Wisconsin Department of Transportation

Proposal #26: 1517-07-72
USH 10 – USH 10/STH 441
County CB – Oneida Street
USH 10
Winnebago County
USH 41 Interchange Phase 1

This is Addendum No. 1, which provides for the following:

DETAIL OF CURB AND GUTTER AT INLETS

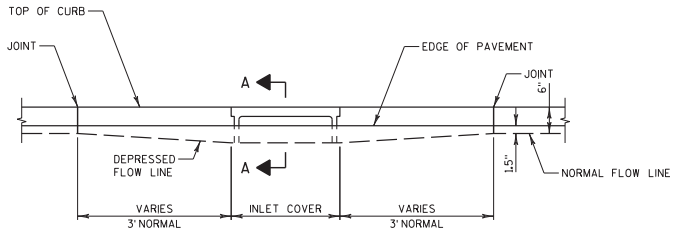
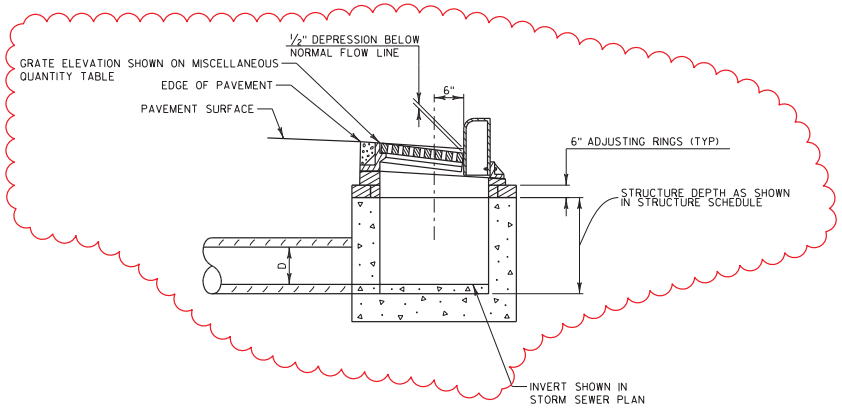
Revised Plan Sheets	
Plan Sheet	Plan Sheet Title (brief description of changes to sheet)
3	Utility Contracts (Updated Utility contacts)
36	Construction Detail (Updated 'Curb & Gutter at Inlets' detail)
37	Construction Detail (Removed 'Removing Inlet Cover and Casting' detail)
41	Construction Detail (Updated both 'Prefabricated Vertical Drain Placement Details …')
47	Removal Plans – Sheet 2 (Added removal of parking lot)
53	Removal Plans – Sheet 8 (Added removal of culvert pipe)
56	Removal Plan (Removed work on WIS 441 EB shoulder)
61	Plan Detail – Prefabricated Vertical Drains (Updated drain tip elevation)
66	Plan Detail – Prefabricated Vertical Drains (Updated location and spacing information)
77	Paving Grades (Updated paving grades)
78	Paving Grades (Updated paving grades)
79	Paving Grades (Updated paving grades)
93	Erosion Control (Added inlet protection)
102	Storm Sewer (Revised rim elevations)
104	Storm Sewer (Added location of temporary storm sewer in plan view)

PROJECT NO: 1517-07-72	HWY: USH 10	COUNTY: WINNEBAGO	CONSTRUCTION DETAILS	SHEET 43A	E

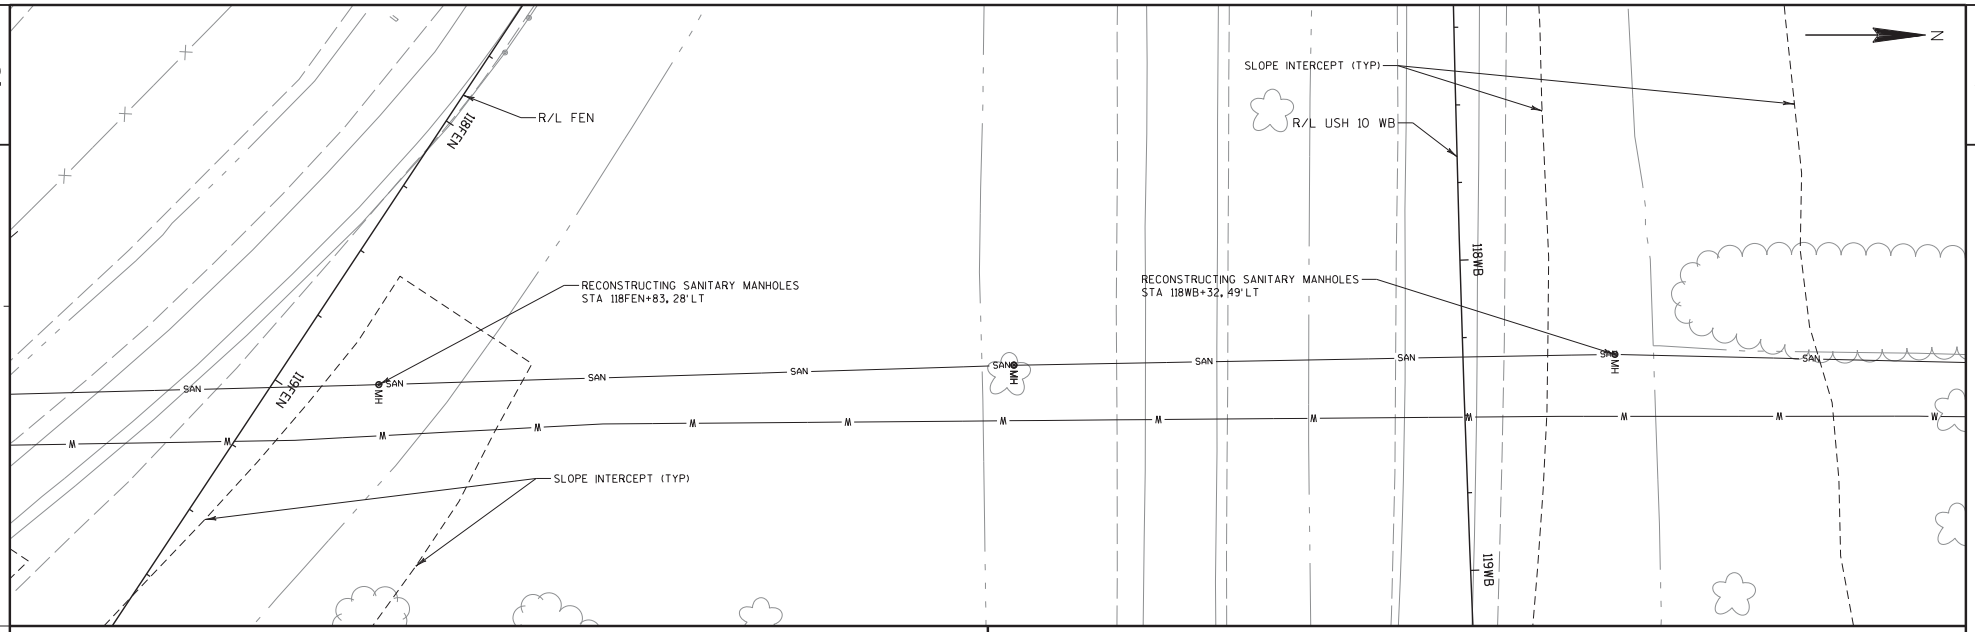
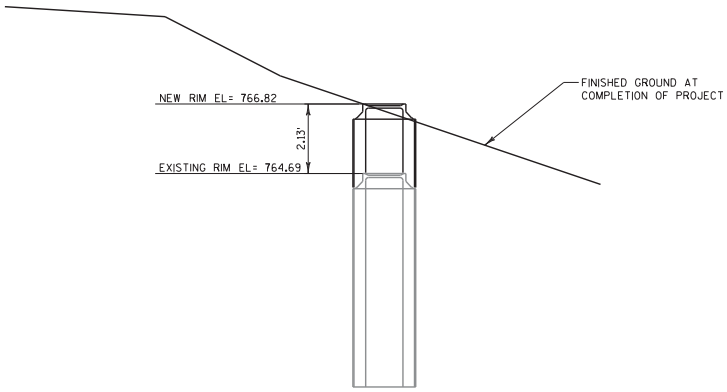
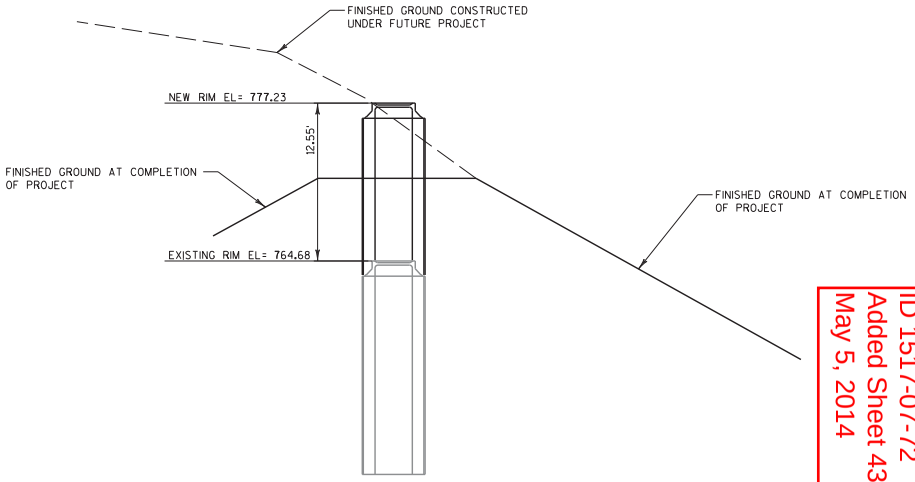
Added Plan Sheets	
Plan Sheet	Plan Sheet Title (brief description of why sheet was added)
43A	Construction Details (Added reconstruction sanitary manholes)
104A	Storm Sewer – Temporary (Added temporary storm sewer)
149A	Traffic Control Plan – Stage 1A & 1B 'Coordinate with 1517-07-76' (Added traffic control coordination with adjacent 1517-07-76 project
630A	Cross Sections – TNE Ramp (Added Station 29TNE+83)

A Description
Reconstruct sanitary manholes in accordance to the plans and specifications, Section 611 of the Standard Specifications and, the 6th Edition Standard Specification for Sewer & Water Construction in Wisconsin.

C Construction
Reconstruction includes removal of the frame, cover, casting, adjusting rings and cone, installation of new barrel sections of appropriate height, reinstallation of the cone, placement of new undamaged adjusting rings, installation of the internal chimney seal, and resetting of the frame and cover. Remove existing frames, covers, castings and manhole cone sections with care to prevent damage. All joints shall be water tight at the time of construction.

PROJECT NO: 1517-07-72	HWY: USH 10	COUNTY: WINNEBAGO	TRAFFIC CONTROL - TYPICAL SECTIONS	SHEET 119	E

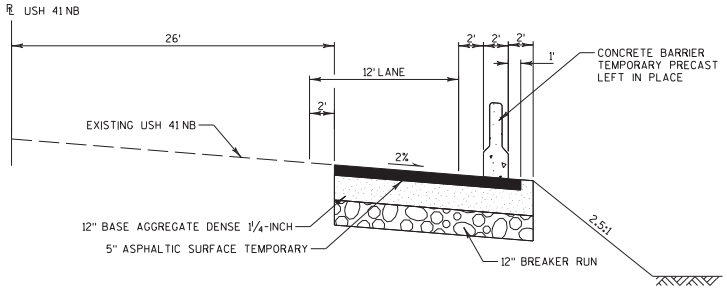
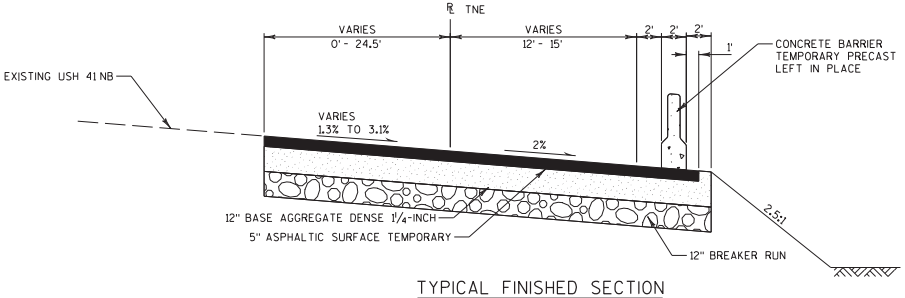
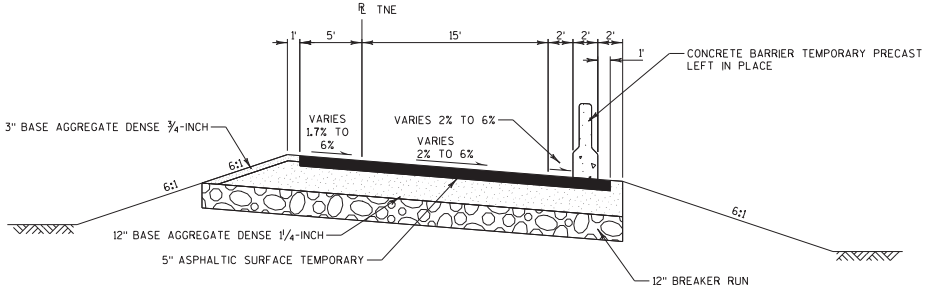
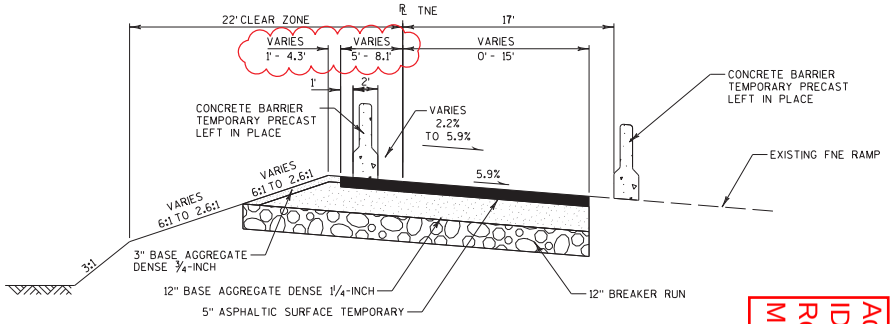
119	Traffic control – Typical Sections (Updated dimensions and station range)
122	Traffic control – Temporary Ramp Paving Grades (Updated paving grades)
125	Traffic Control Alignment – Temporary Ramps (Updated alignment information)
127	Traffic Control – Plan & Profile Temporary Ramp TNE (Updated profile)
131	Traffic Control – Construction Details (Added Emergency Access sign to detail)
132	Traffic Control – Construction Details (Added Emergency Access sign to detail)
138	Traffic Control Plan – Preliminary Stage Sheet 3 (Extended temporary barrier)
143	Traffic Control Plan – Preliminary Stage Sheet 3 (Extended temporary barrier)
149	Traffic Control Plan – Stage 1A & 1B Sheet 2 (Moved traffic control to match realigned ramp)
155	Traffic Control Plan – Stage 1A & 1B Sheet 8 (Added temp barrier)
156	Traffic Control Plan – Stage 1A & 1B Sheet 9 (Added temp barrier)
161	Traffic Control Left In Place Plan – Sheet 2 (Added coordination note)

SECTION THRU WINGWALLS

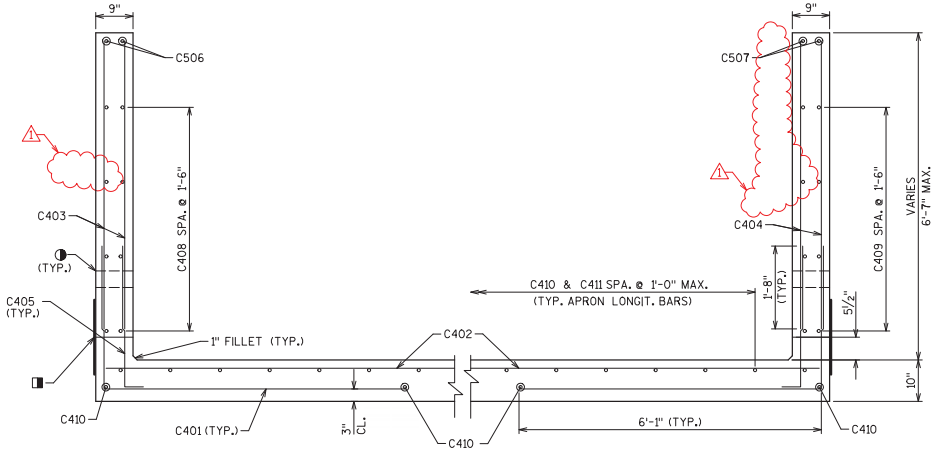
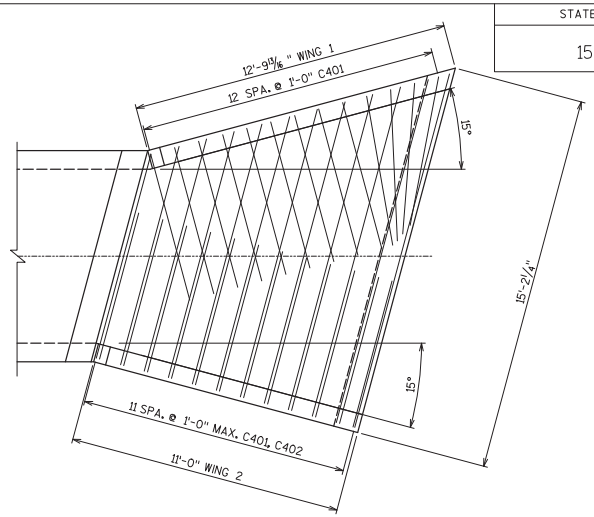
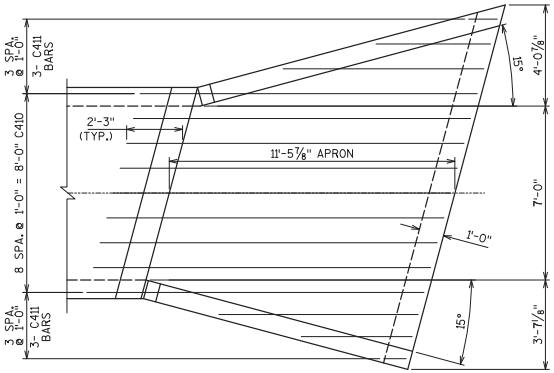
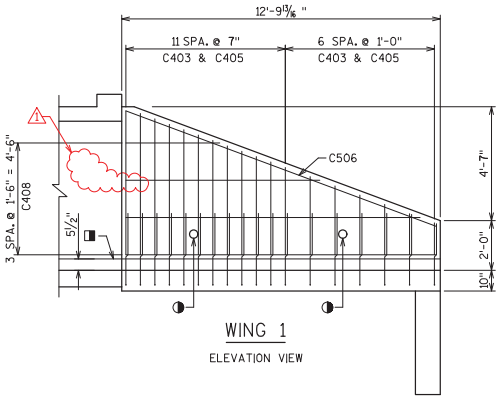
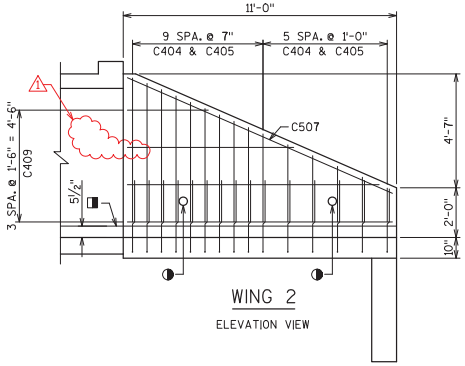
192	Miscellaneous Quantities (Revised 'Concrete Barrier' & 'Pipe Underdrain' tables)
194	Miscellaneous Quantities (Revised 'Water' & 'Restoration' tables)
195	Miscellaneous Quantities (Revised 'Inlet Protection' table)
199	Miscellaneous Quantities (Revised 'Traffic Control' table)
200	Miscellaneous Quantities (Revised 'Sawcuts' table)
201	Miscellaneous Quantities (Added 'Reconstructing Sanitary Manholes' table)
202	Miscellaneous Quantities (Revised 'Prefabricated Vertical Drains' table)
209	Plan & Profile – USH 10 WB (Updated profile)
211	Plan & Profile – USH 10 WB (Added Salvage and Reinstall Pipe Underdrain and Apron Endwall)
348	B-70-402 (Added Temporary Shoring at Pier 5 between Lake Street and Pier 5)
349	B-70-402 (Revised estimated quantity for Temporary Shoring)
367	B-70-402 (Added Temporary Shoring at Pier 5)
404	C-70-42 – Apron and Wingwall Details (Removed dowel bar between wingwall and box wall)

SECTION THRU WINGWALLS

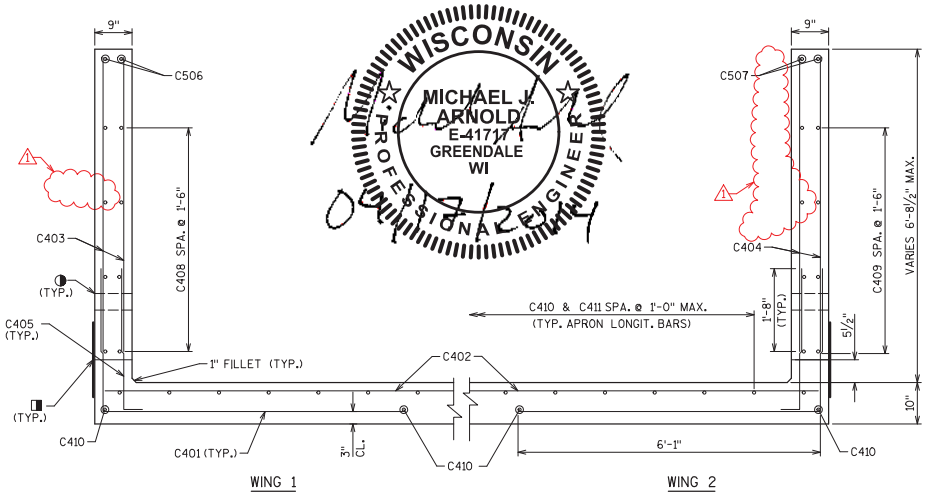
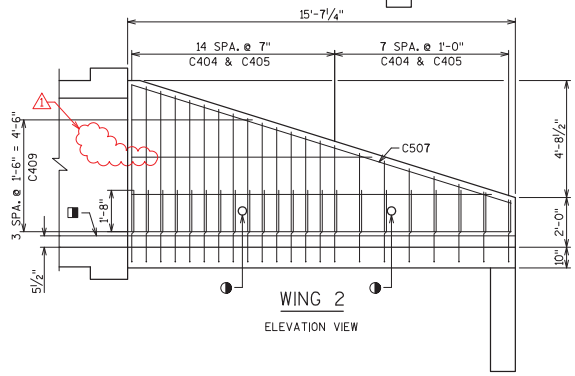
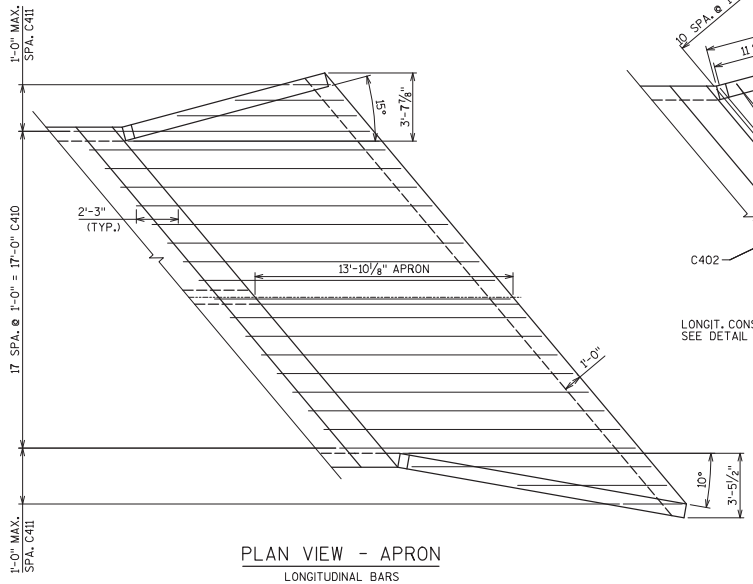
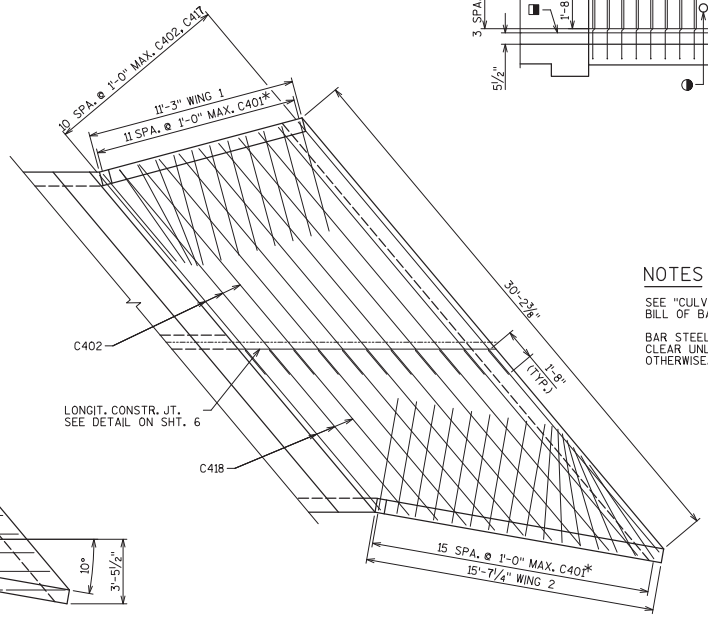
411	C-70-54 – Apron and Wingwall Details (Removed dowel bar between wingwall and box wall)
441	R-70-115 – Design Data and Quantities (Revised top of wall elevations and wall quantity)
472	Earthwork Summary (Revised USH 41 NB 3 earthwork)
481	Earthwork Summary (Revised TNE Ramp earthwork)
511	Cross Sections – USH 41 NB (Revised USH 41 NB cross-sections)
512	Cross Sections – USH 41 NB (Revised USH 41 NB cross-sections)
513	Cross Sections – USH 41 NB (Revised USH 41 NB cross-sections)
514	Cross Sections – USH 41 NB (Revised USH 41 NB cross-sections)
515	Cross Sections – USH 41 NB (Revised USH 41 NB cross-sections)
626	Cross Sections – TNE Ramp (Revised TNE cross-sections)
627	Cross Sections – TNE Ramp (Revised TNE cross-sections)
628	Cross Sections – TNE Ramp (Revised TNE cross-sections)
629	Cross Sections – TNE Ramp (Revised TNE cross-sections)
630	Cross Sections – TNE Ramp (Revised TNE cross-sections)
